ADDENDUM NO. 2

**Three Rivers Community Schools – Three Rivers Middle School Additions and
Renovation**

SHEET CLARIFICATIONS / REVISIONS

UNIT 'A' HYDRONIC PLAN
1/8" = 1'-0"

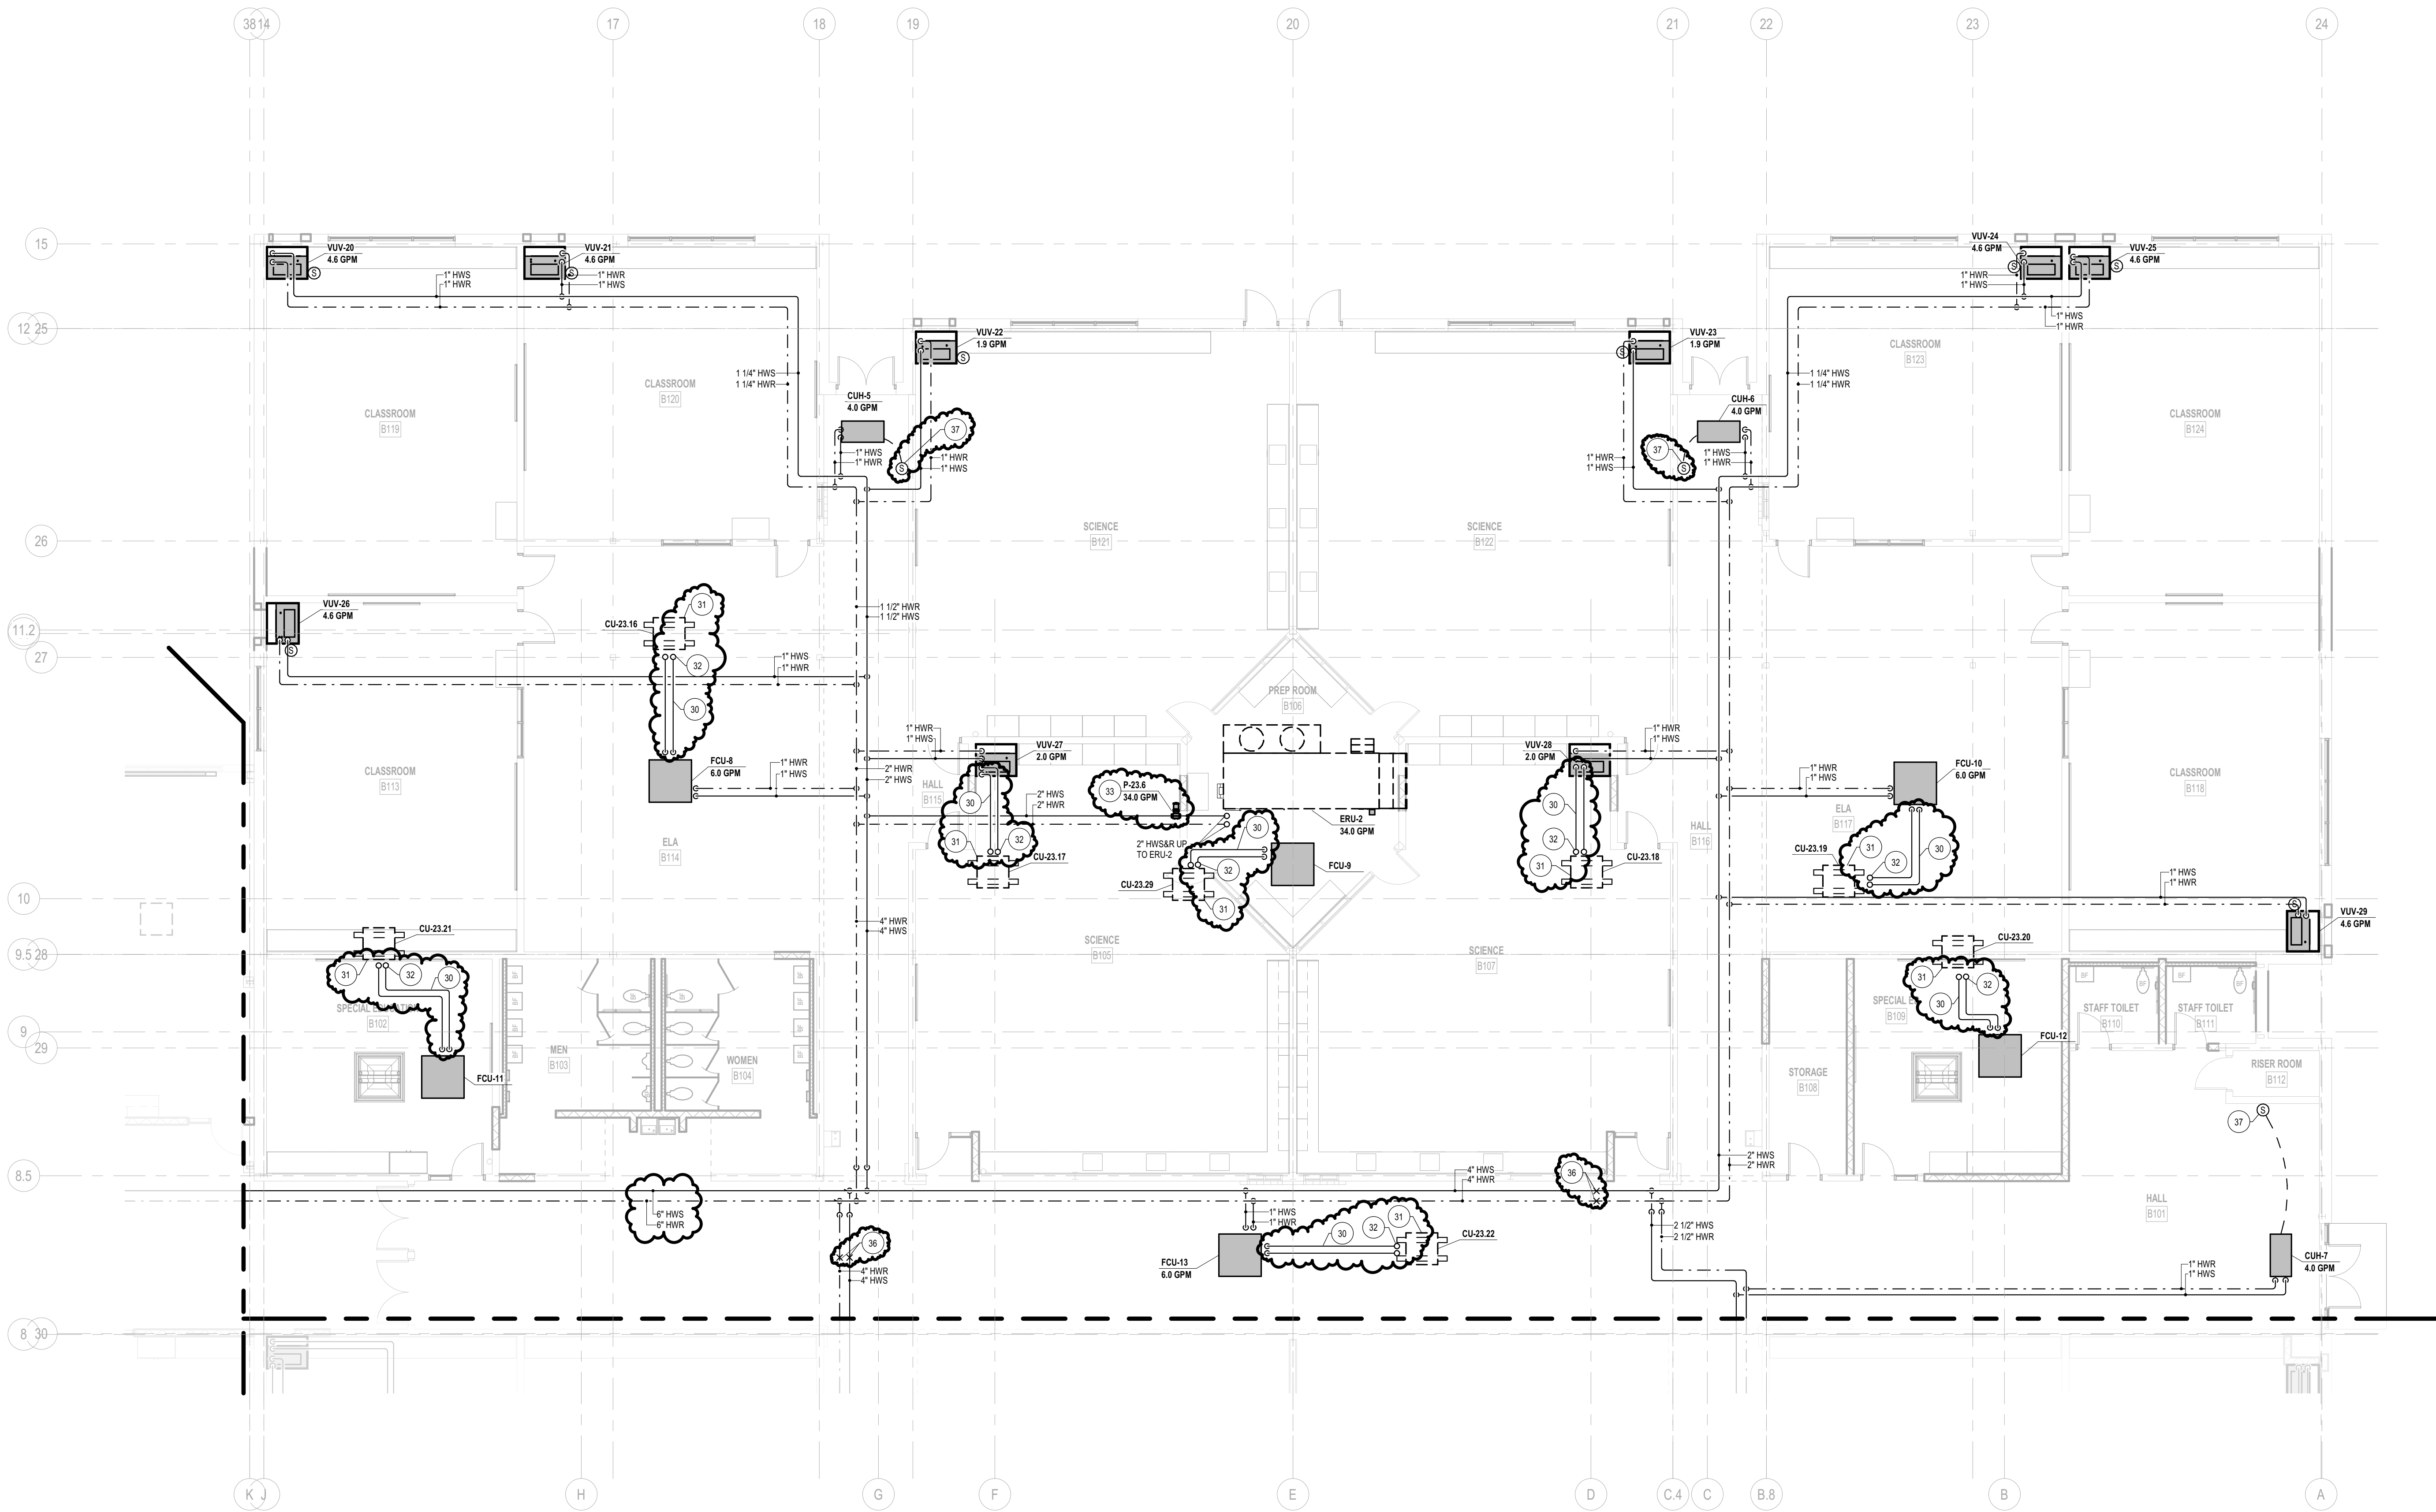
ITEM NO. 40 SHEET M3.1A UNIT 'A' HYDRONIC PLAN (REISSUED)

- A. Added mechanical keynotes.
- B. Mechanical Keynote Legend, refrigerant piping, hot water coil circulating pump to energy recovery unit ERU-23.1 and pipe anchors to hot water heating system piping.

UNIT 'C' HYDRONIC PLAN
1/8" = 1'-0"

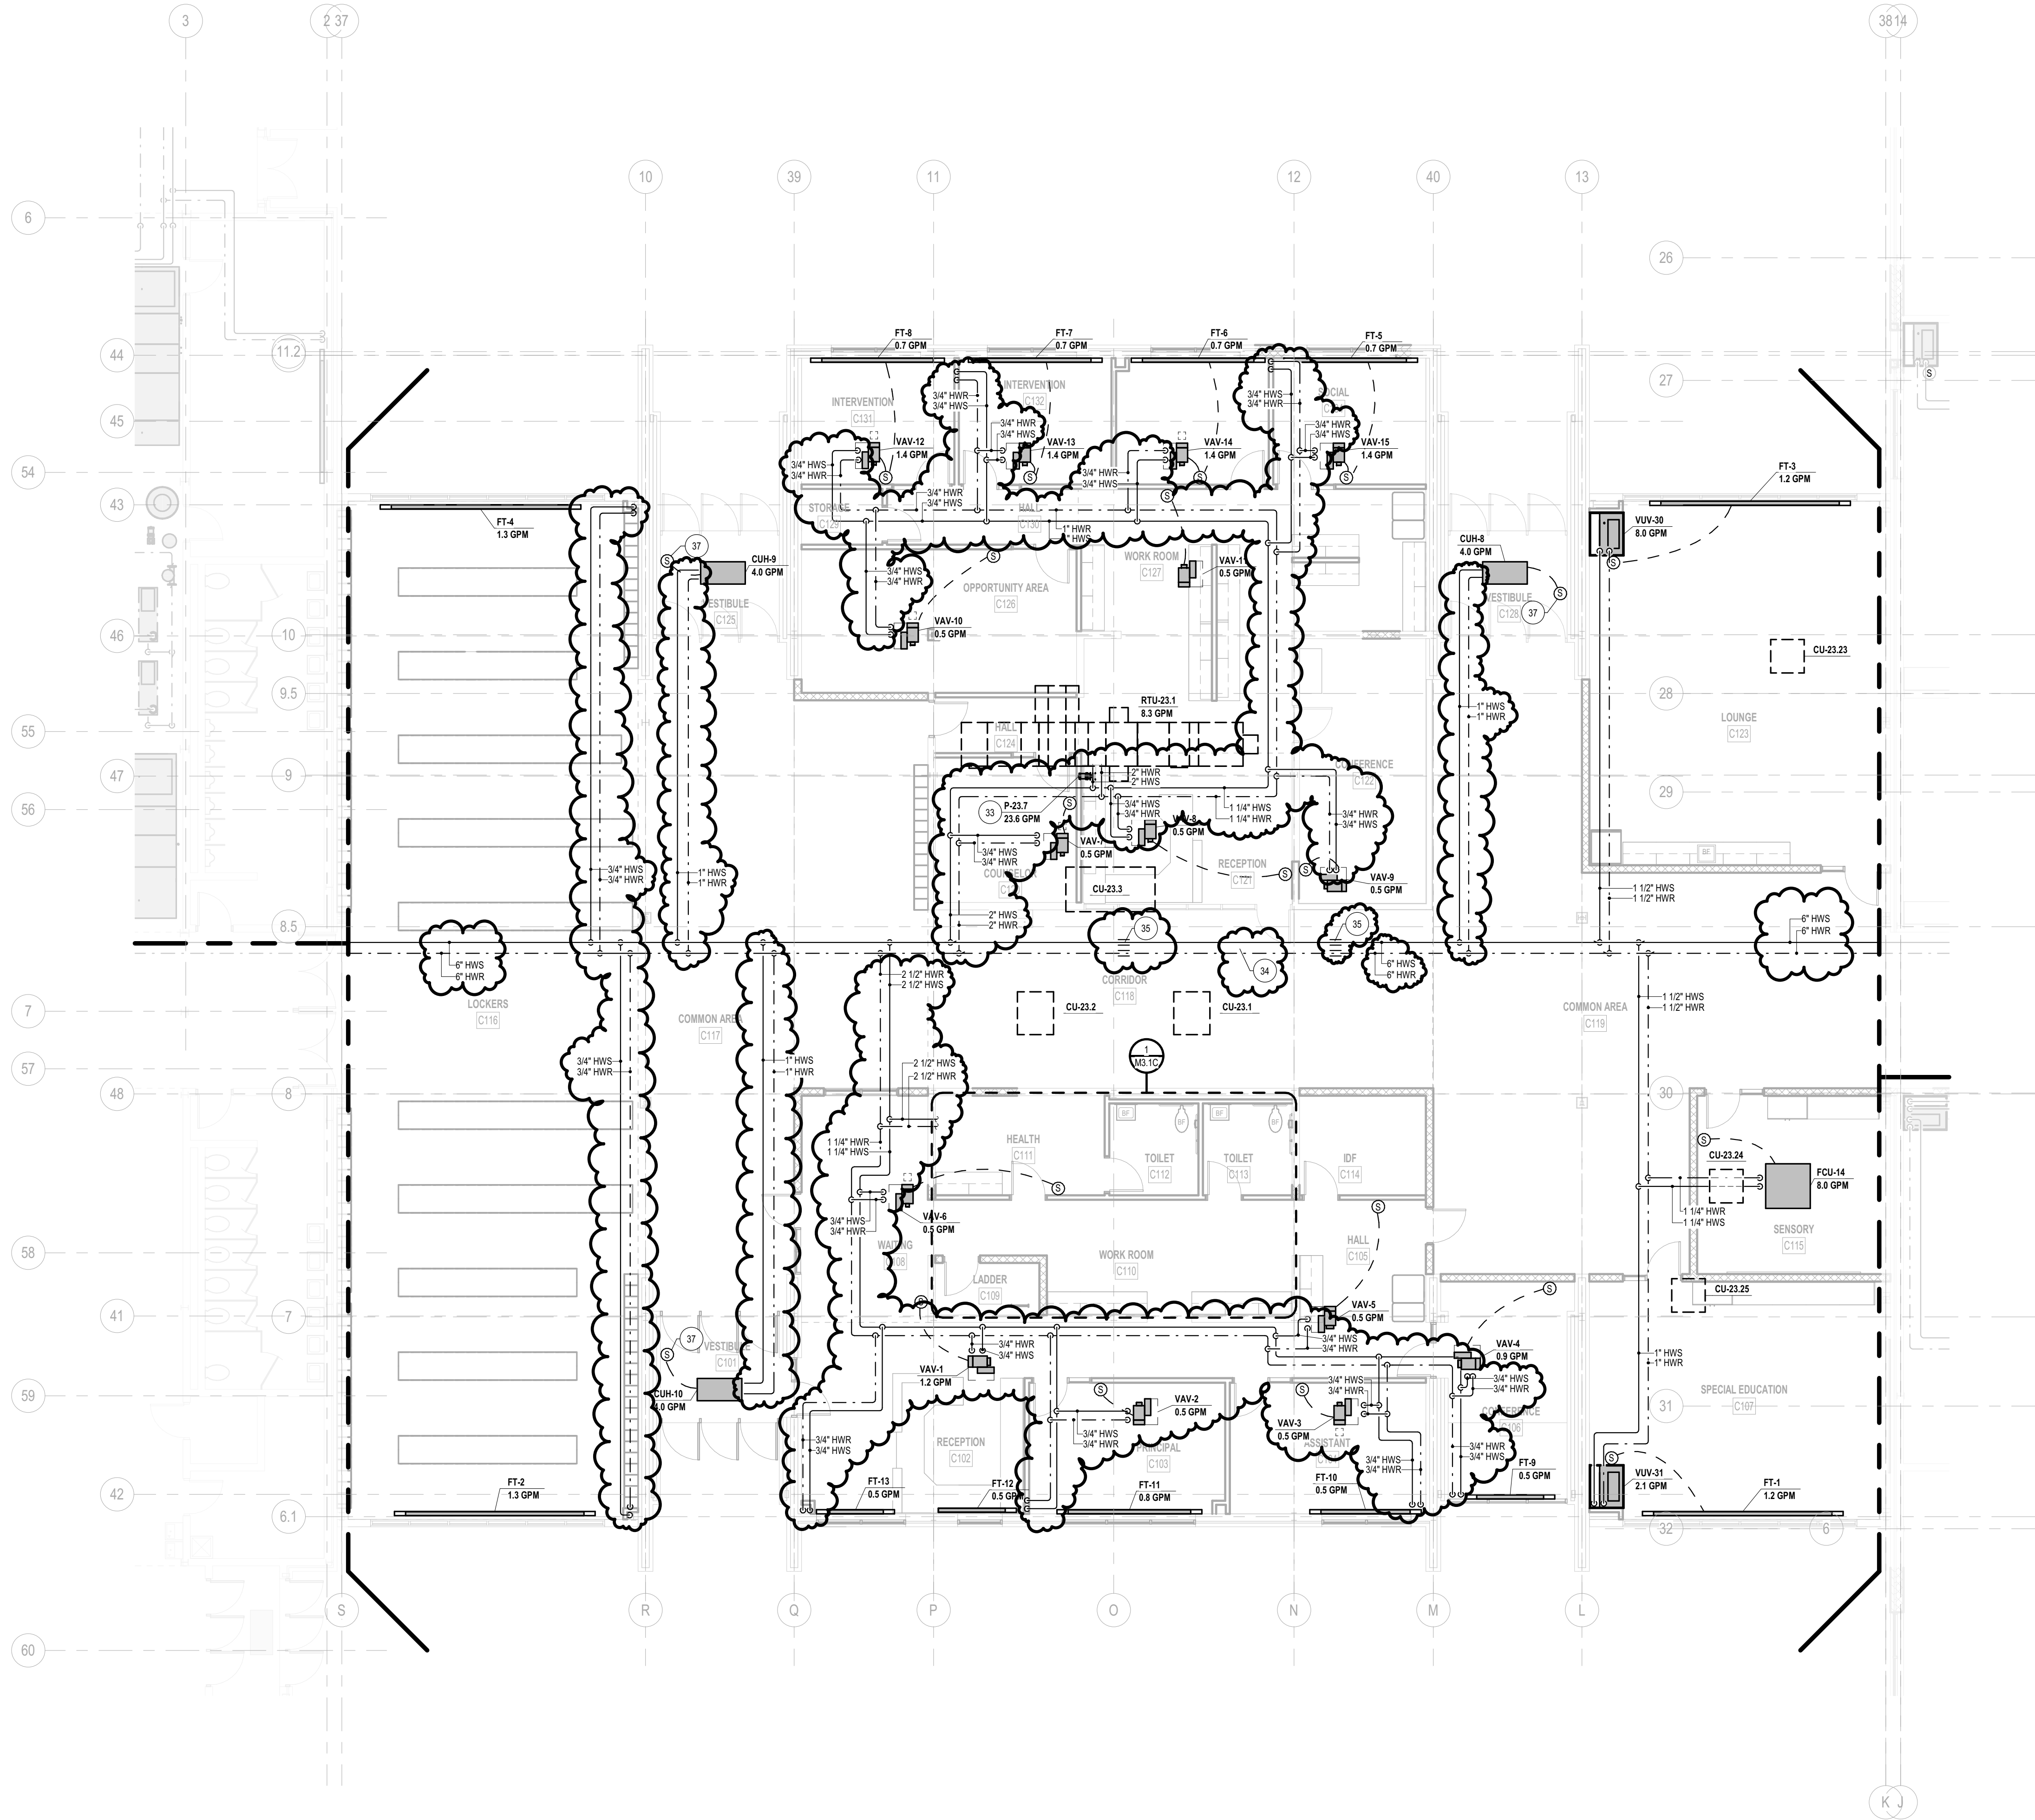
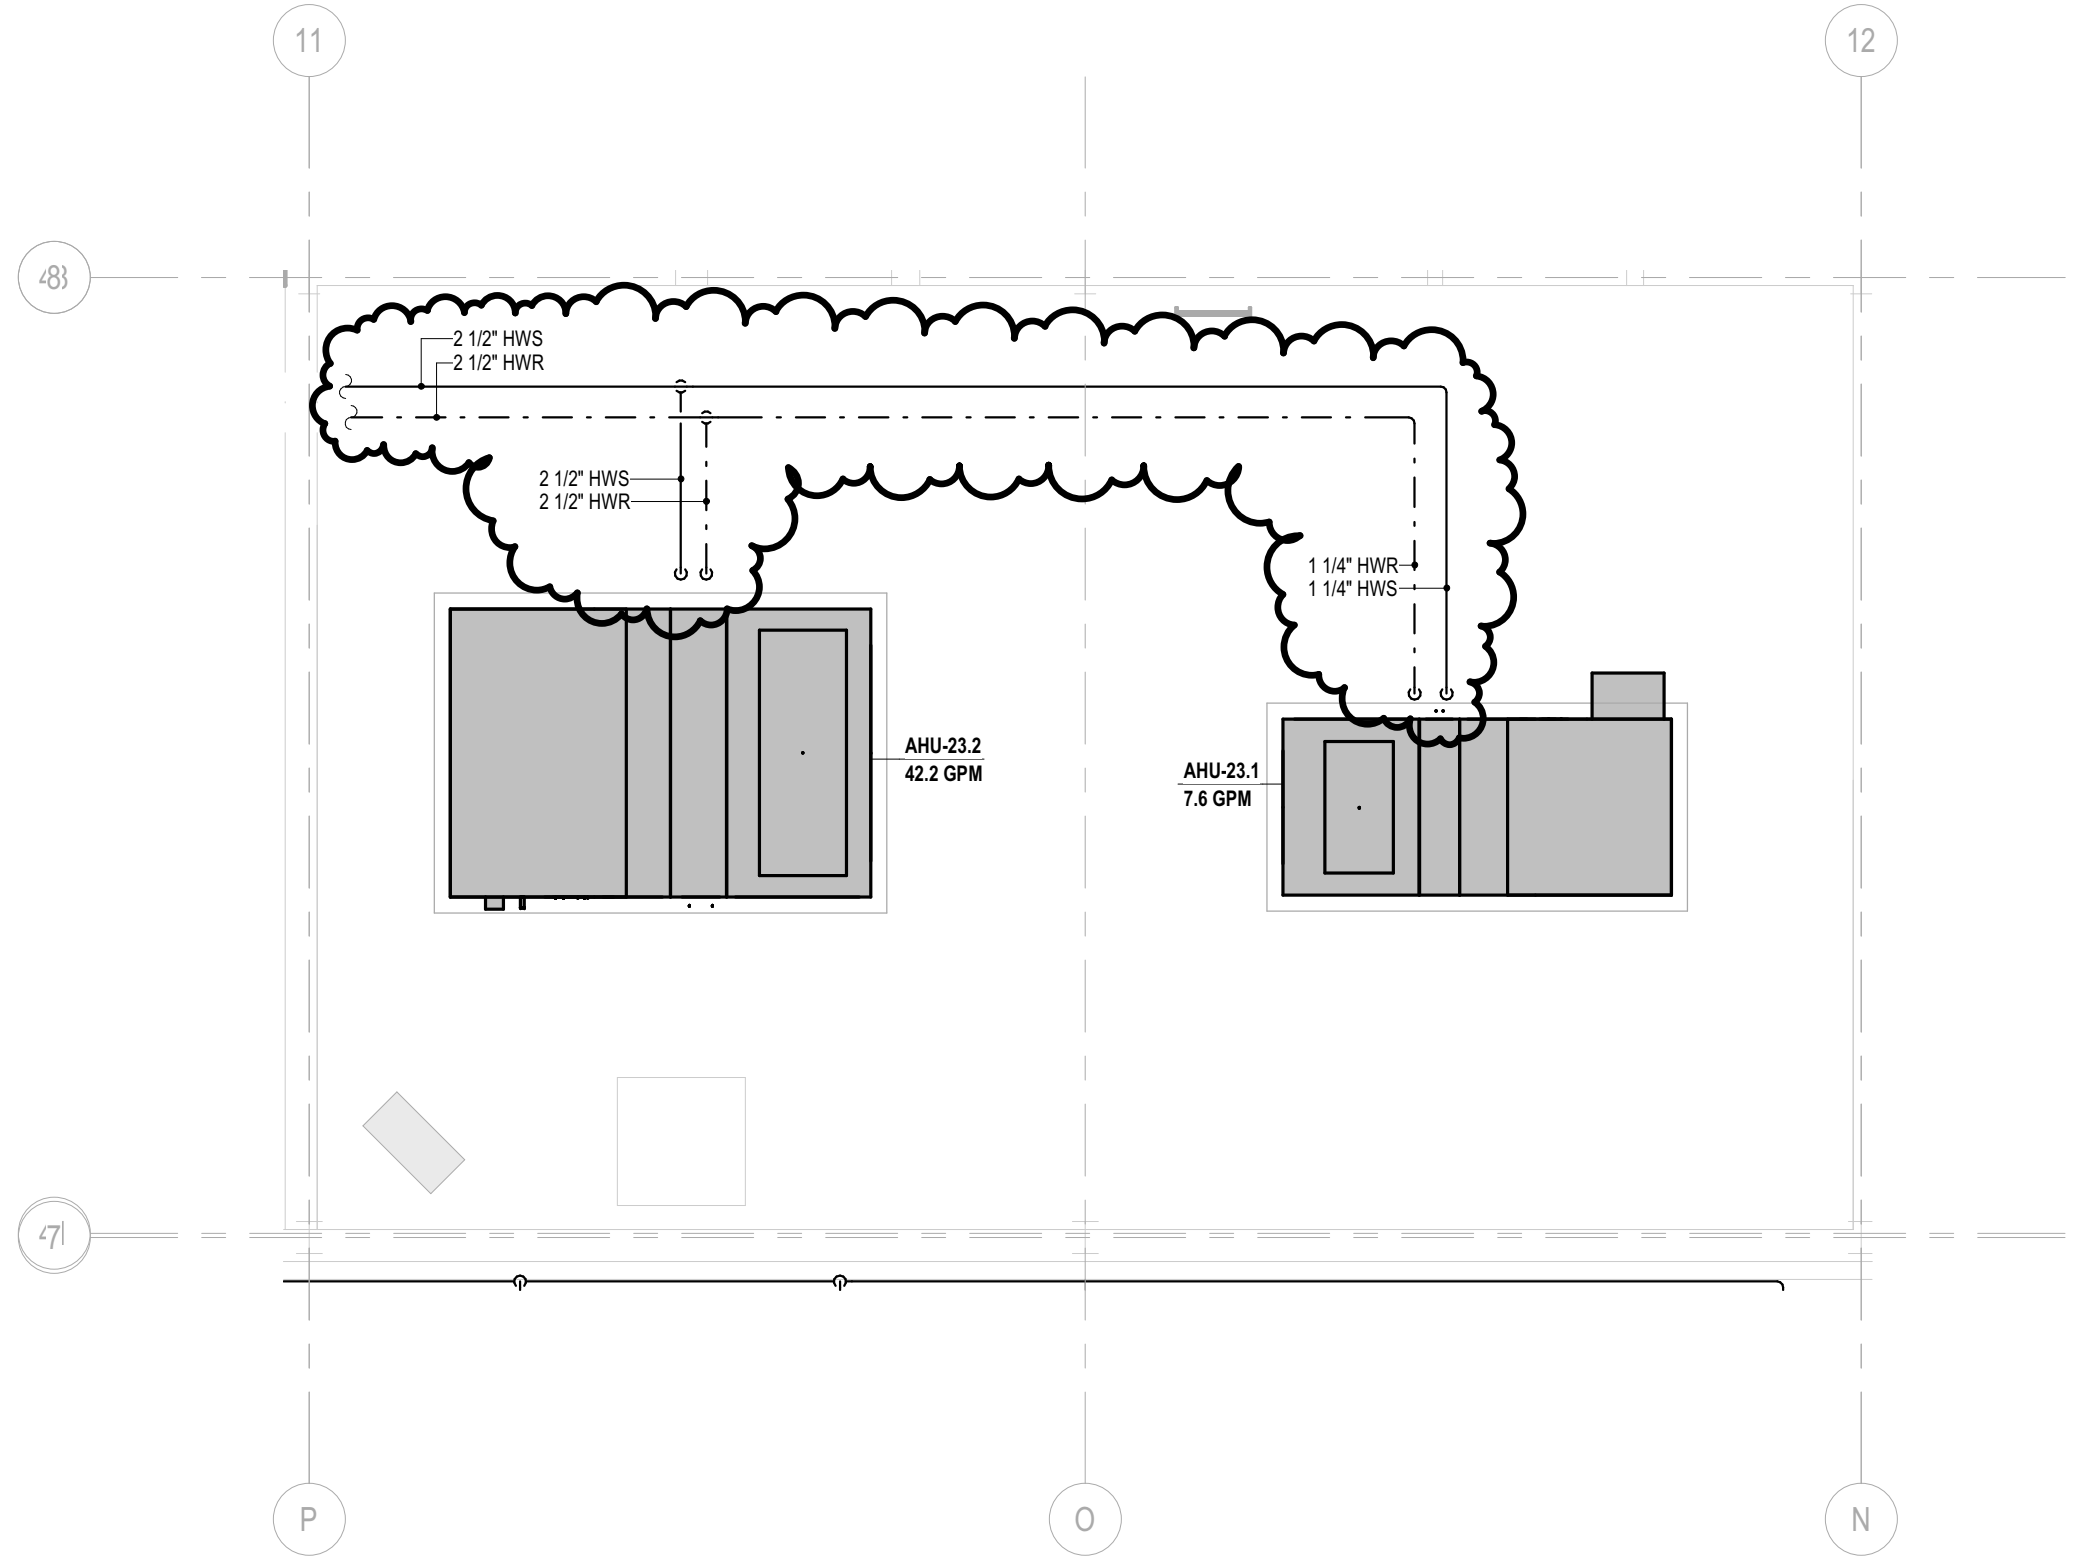
ITEM NO. 42 SHEET M3.1C UNIT 'C' HYDRONIC PLAN (REISSUED)

- A. Added mechanical keynotes.
- B. Added Mechanical Keynote Legend.
- C. Added refrigerant piping, hot water heating system piping and sizes, hot water coil circulating pump to rooftop unit RTU-23.1 and pipe anchors/guides/expansion joints to the hot water heating system piping.
